Narrative

Date: July 31, 2026
Project: 24047 – NKU Civic Center Renovation
From: Jeff Fackler
Narrative: Addendum C

A0.50 - Overall Slab Plan - Lower Level

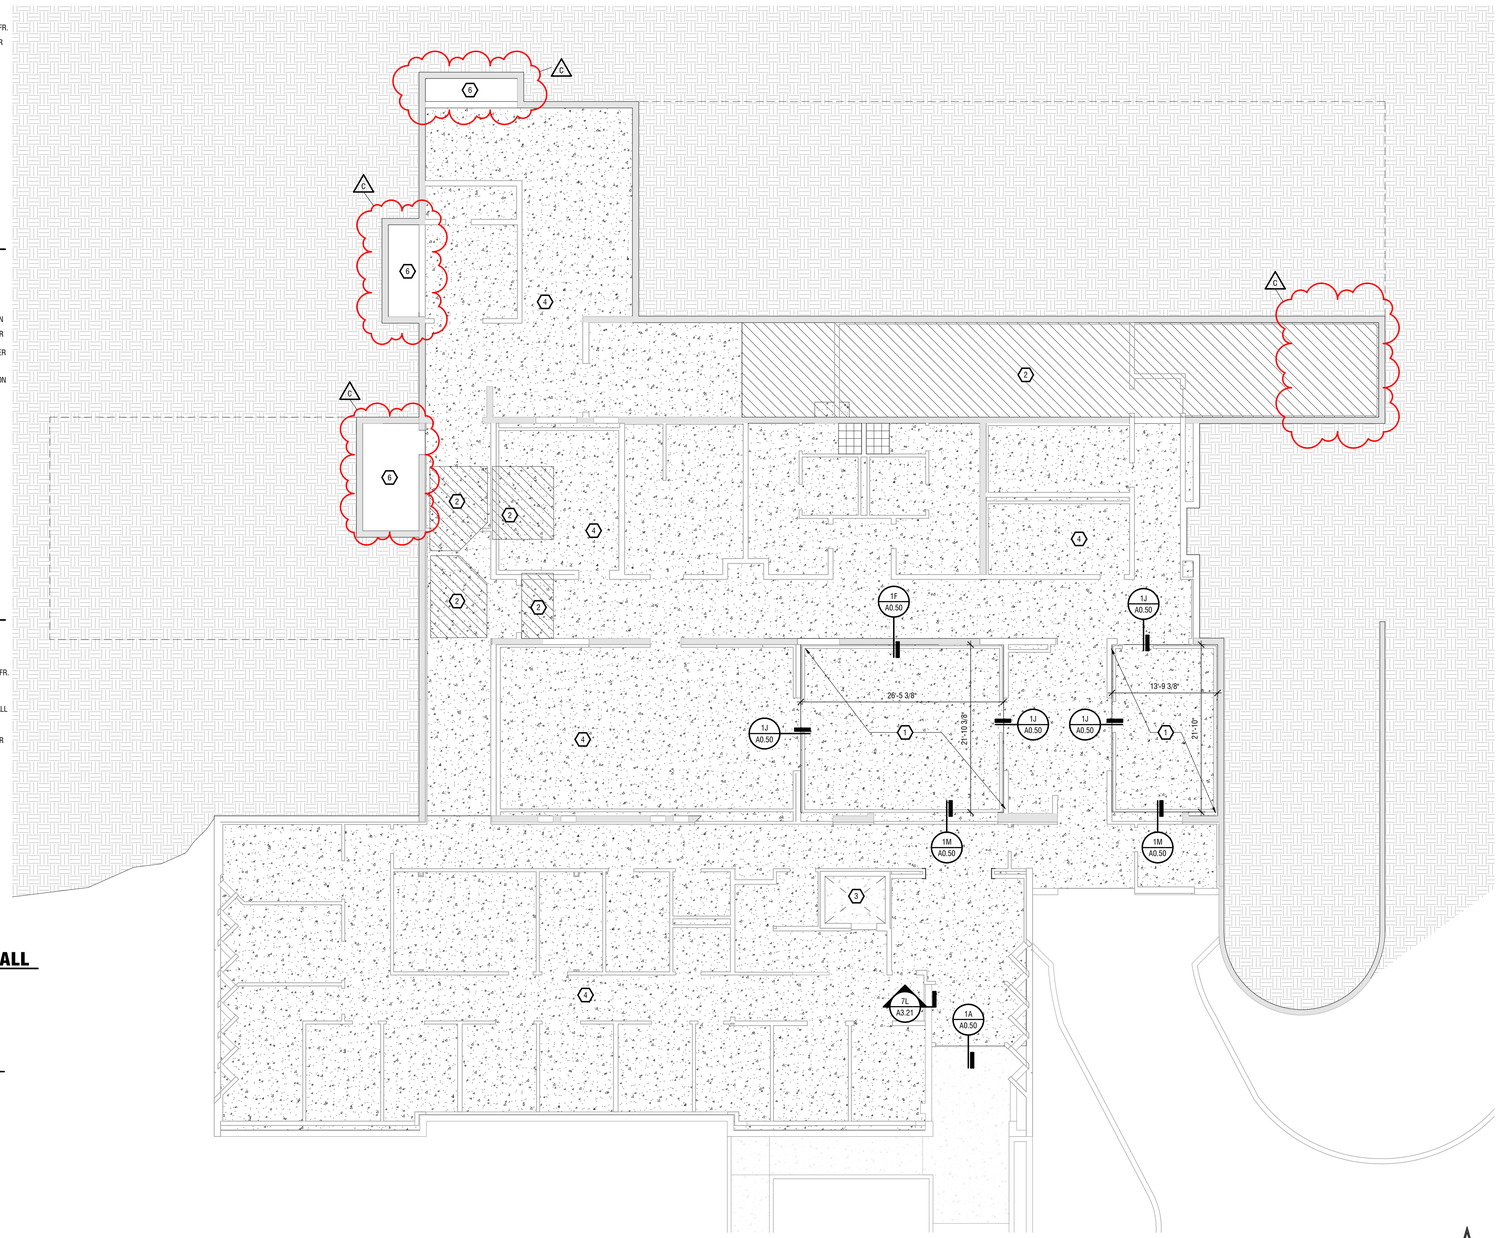
Revise extents of existing slab demolition and added Keynotes 6 to describe the extents.

Extend scope of hatched area with Keynote 2 for recessed area to receive geofoam and raise the floor.

A1.01 - Overall Floor Plan – Lower Level

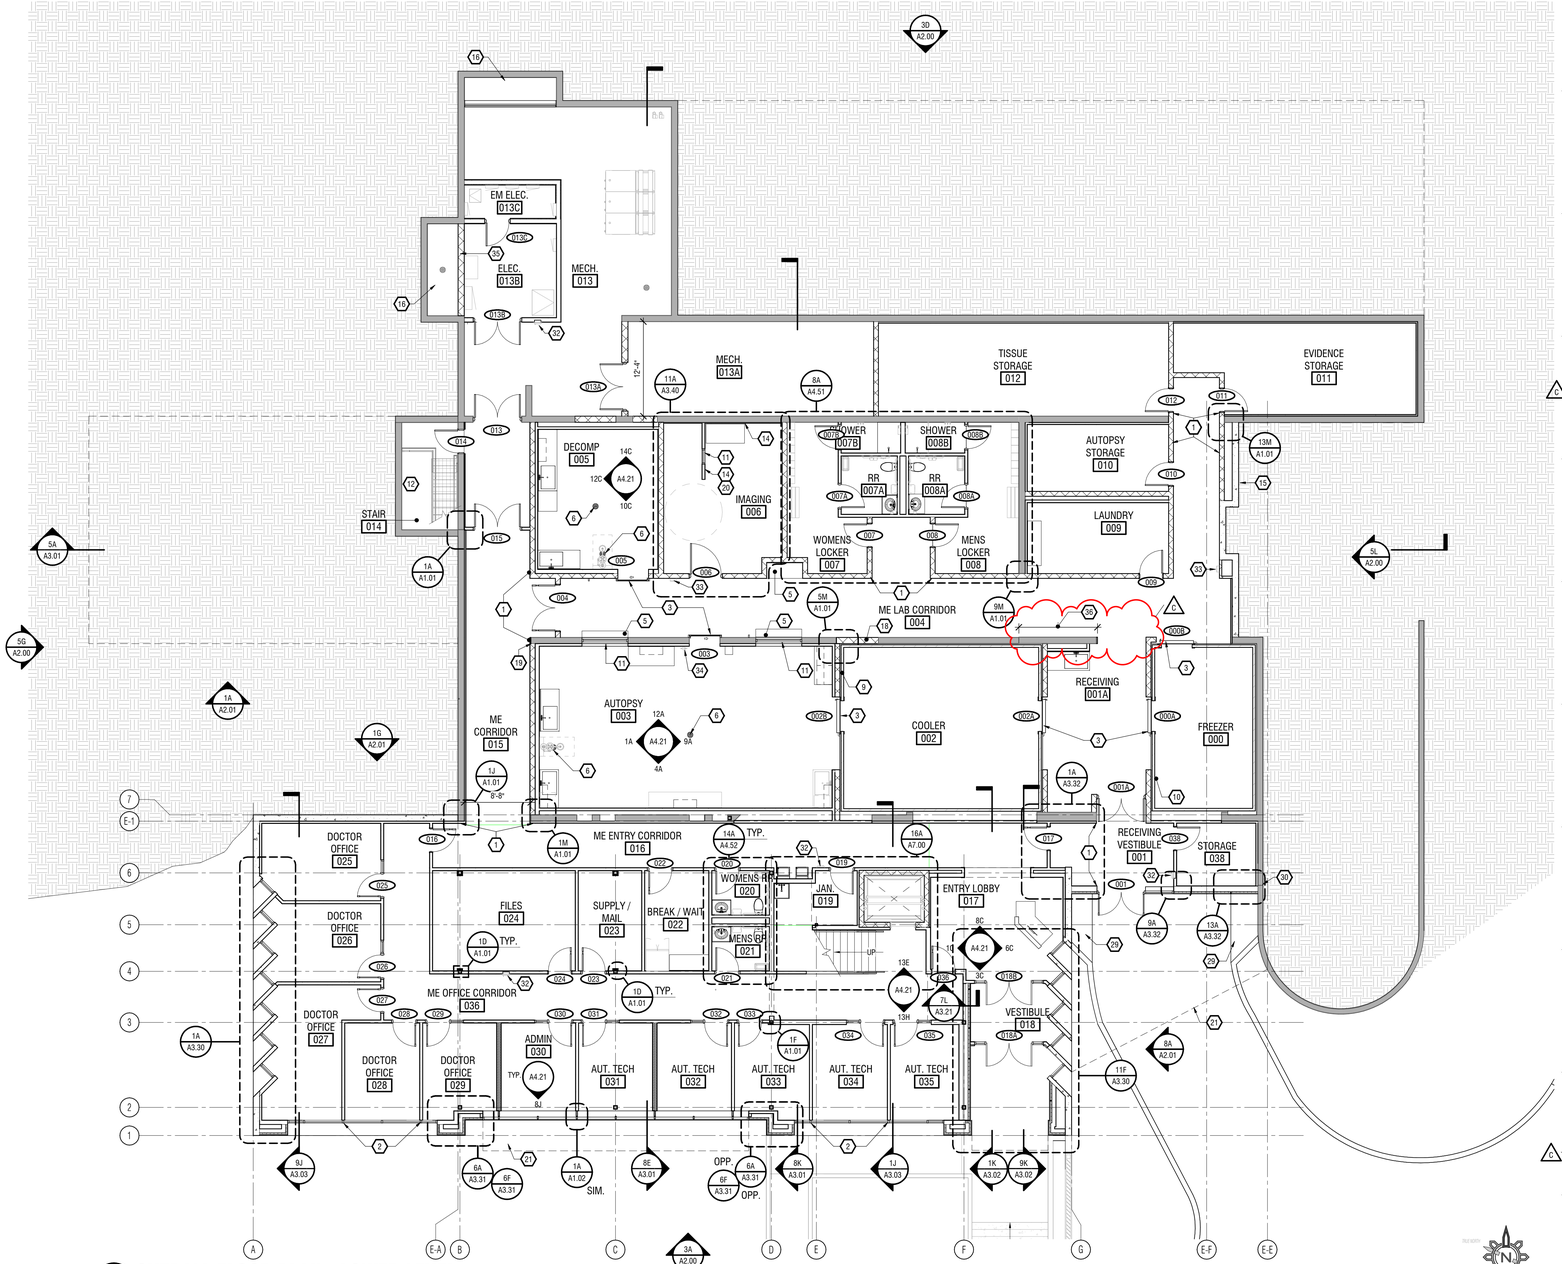
Add note to grind the face of the existing wall to prepare for new finishes.
Add General Note to patch existing concrete floor smooth at all demolition locations.

A1.02 - Overall Floor Plan – Upper Level

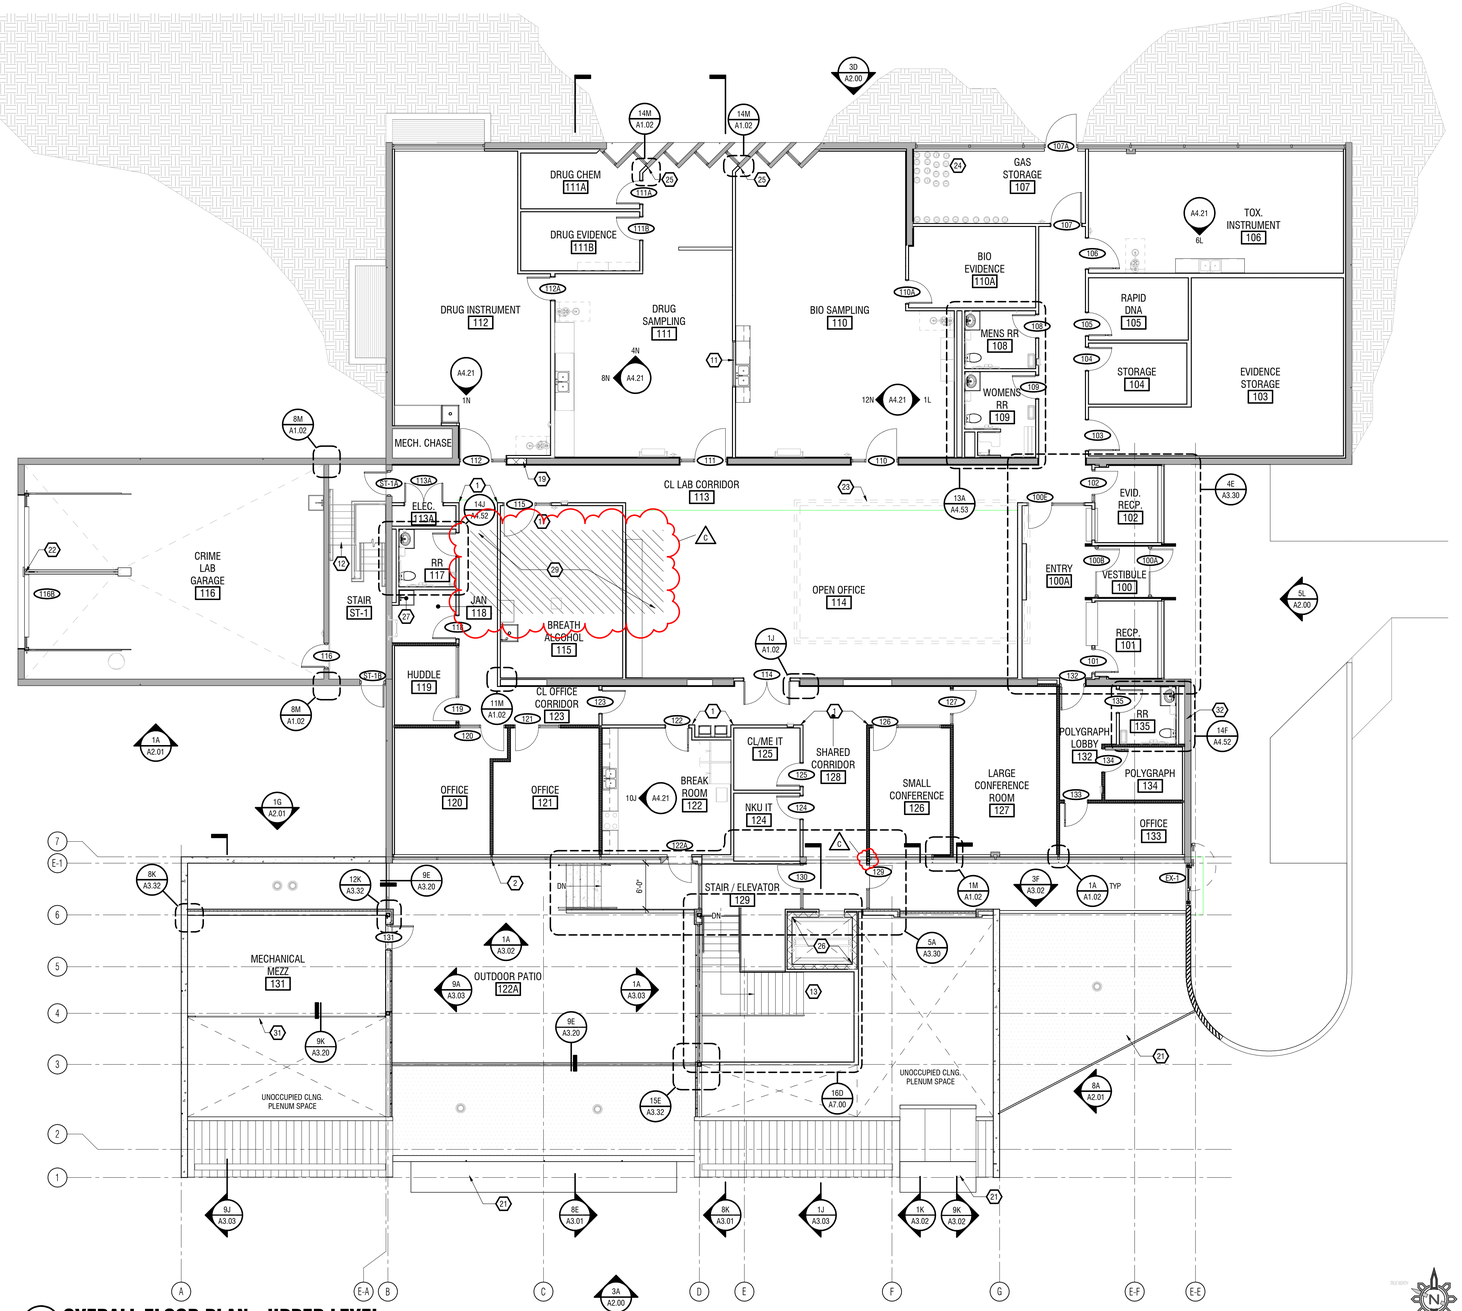
Add notes and graphics to capture scope of patching the remaining penetrations in the floor slab.
Add General Note to patch existing concrete floor smooth at all demolition locations.

A1.03 - Overall Roof Plan

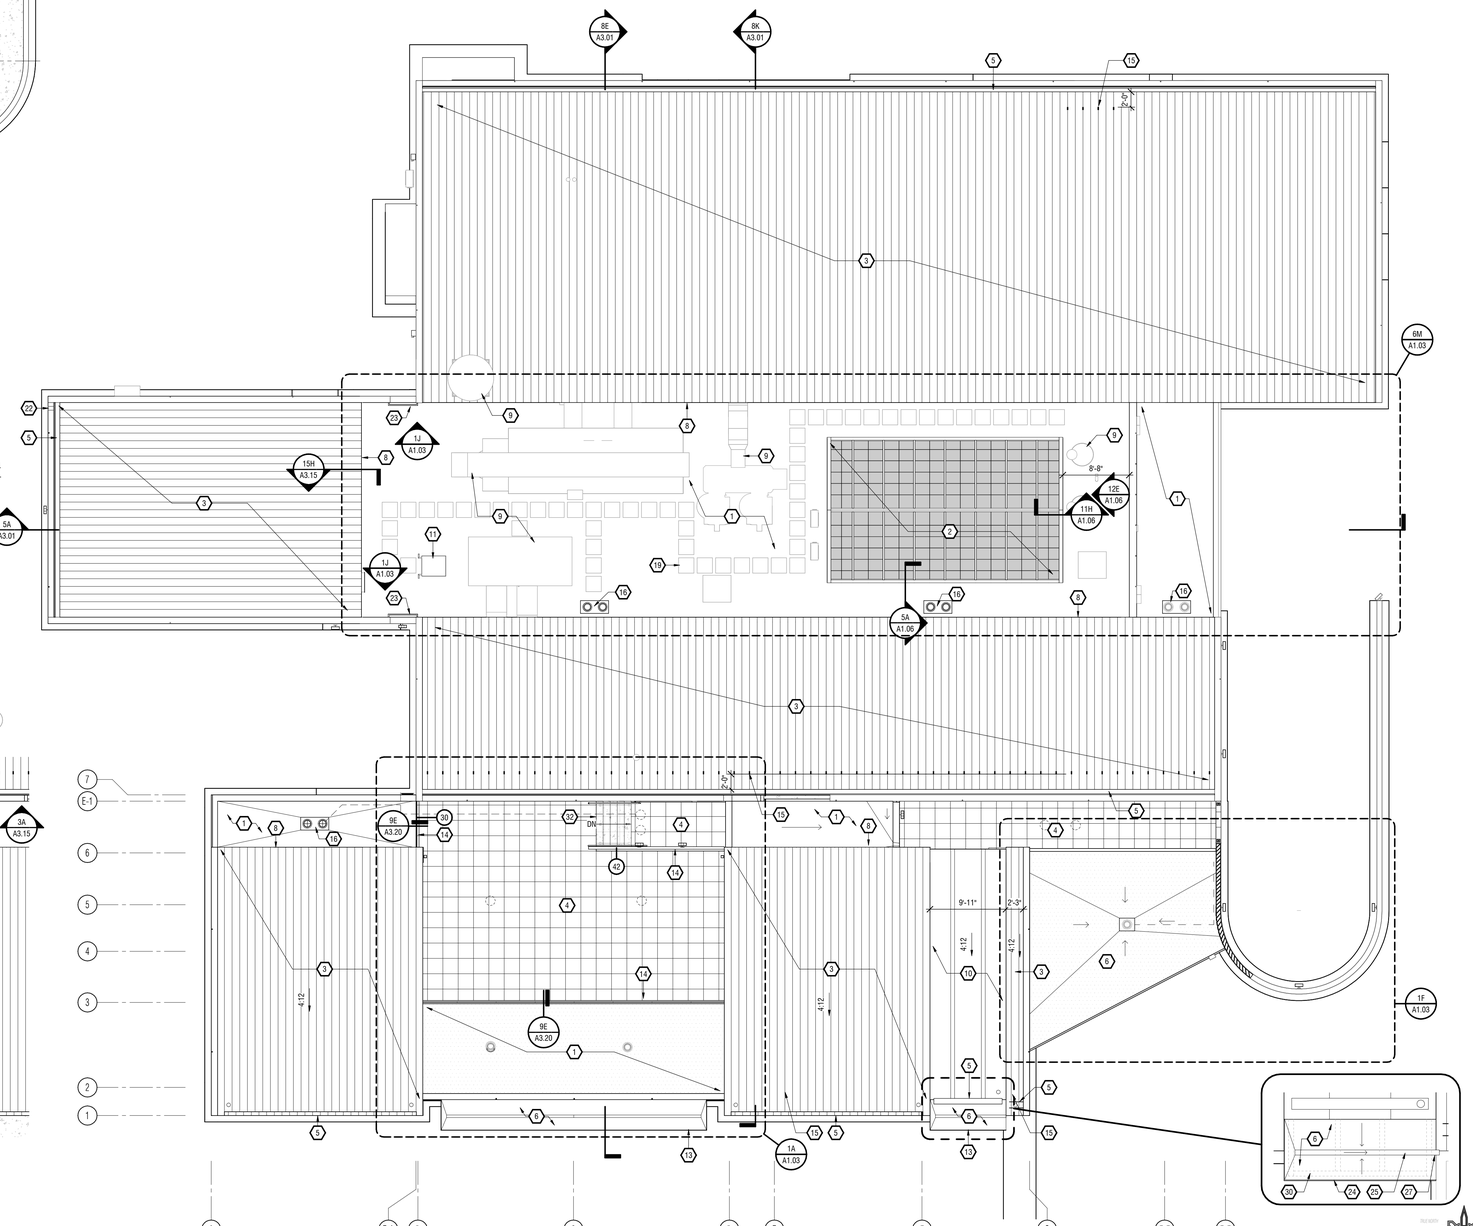
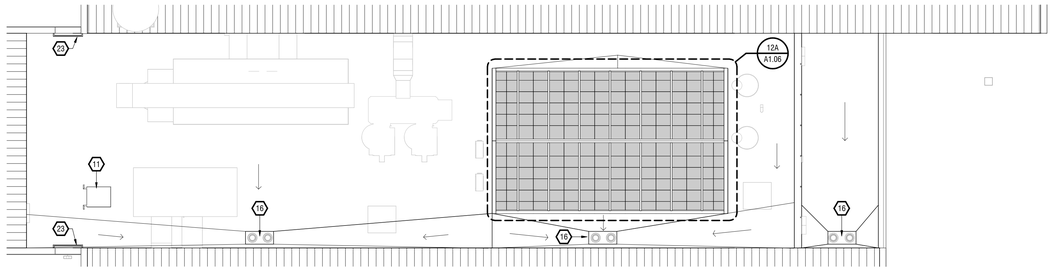
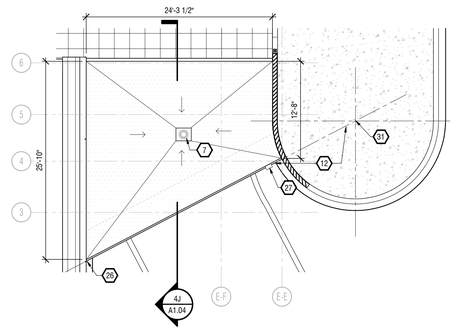
Revise scope of EPDM roofing to TPO roofing

A1.10 – Overall Dimension Plan – Lower Level

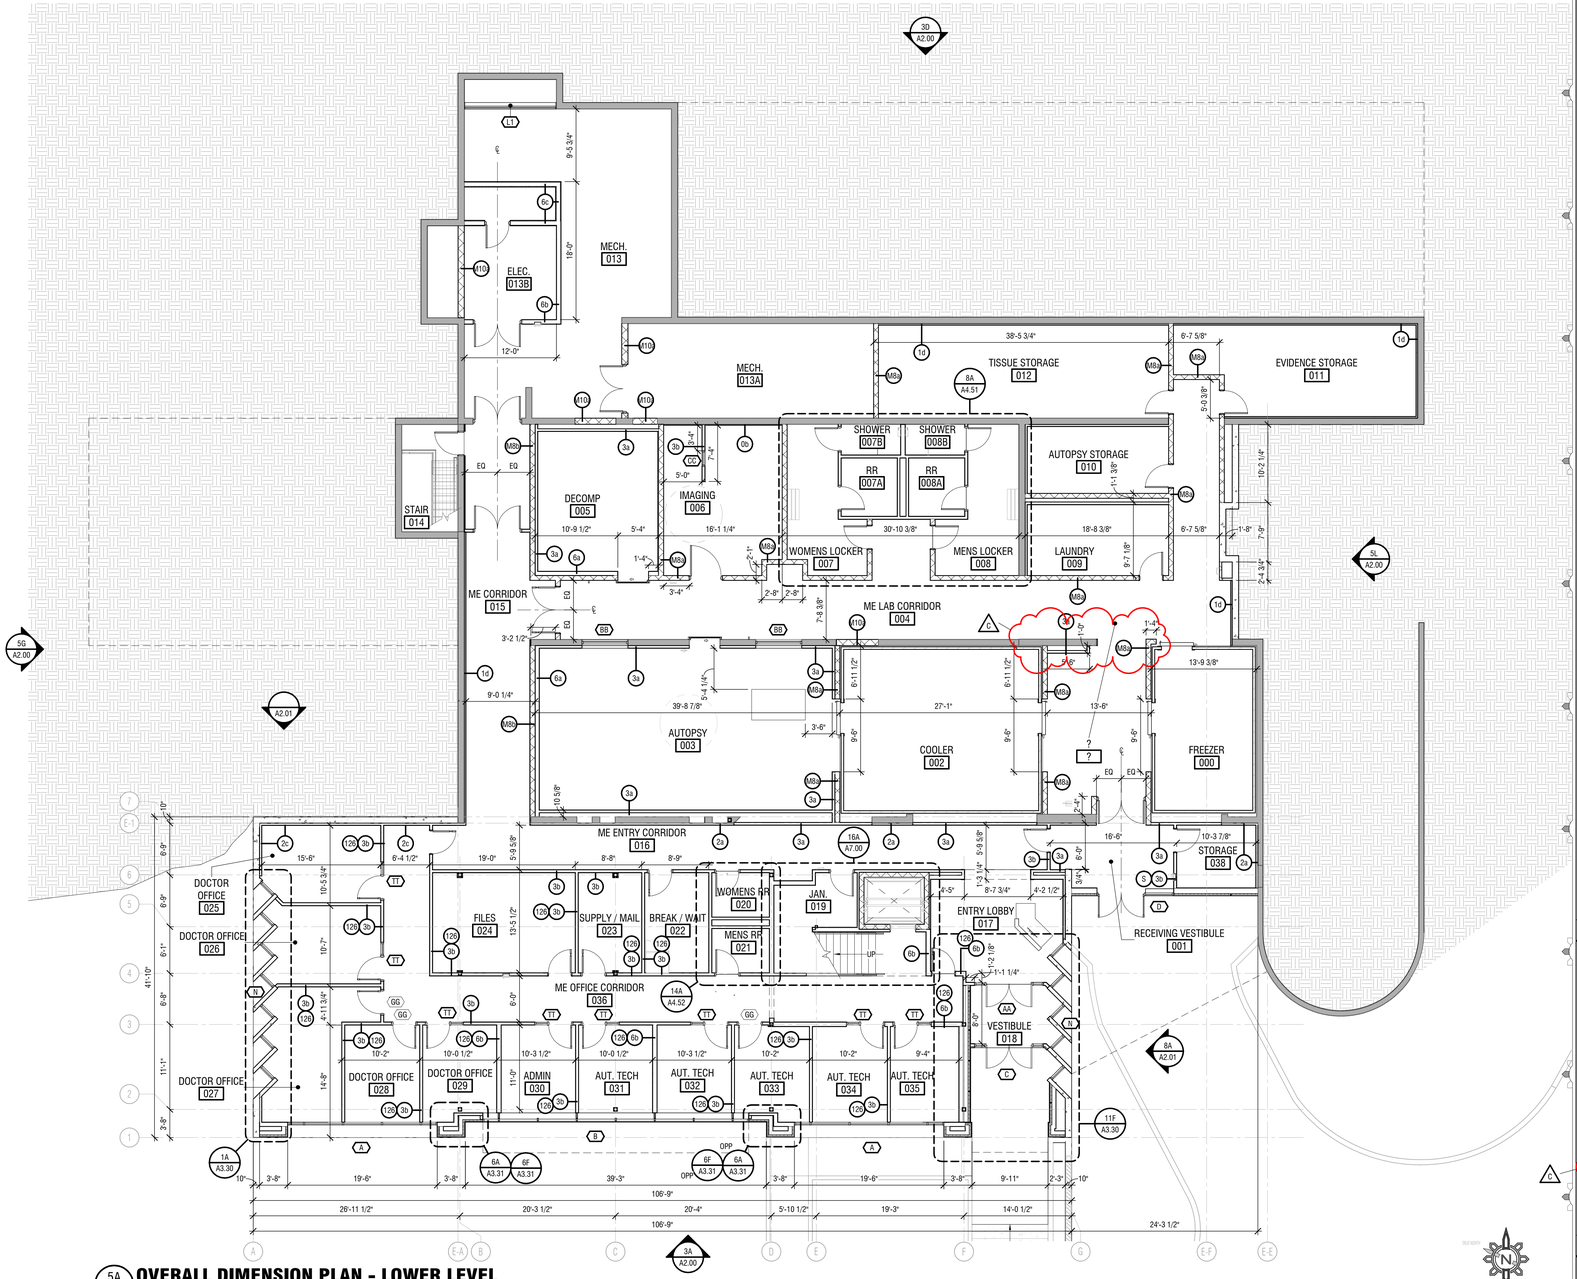
Revise dimension and scope of existing wall to remain.
Add General Note to patch existing concrete floor smooth at all demolition locations.
